Accessibility

Audit Report

BusConnects Radial Core Bus Corridors Infrastructure Upgrade Programme – Project B

Liffey Valley to City Centre Core Bus Corridor -Accessibility Audit Report

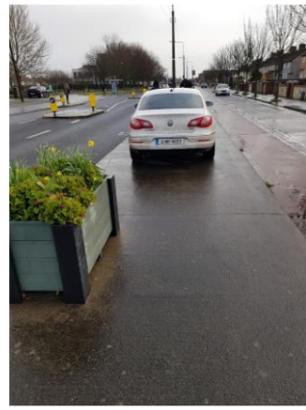
708912,733788

Solution: Raise the driveway to meet the required standard height.
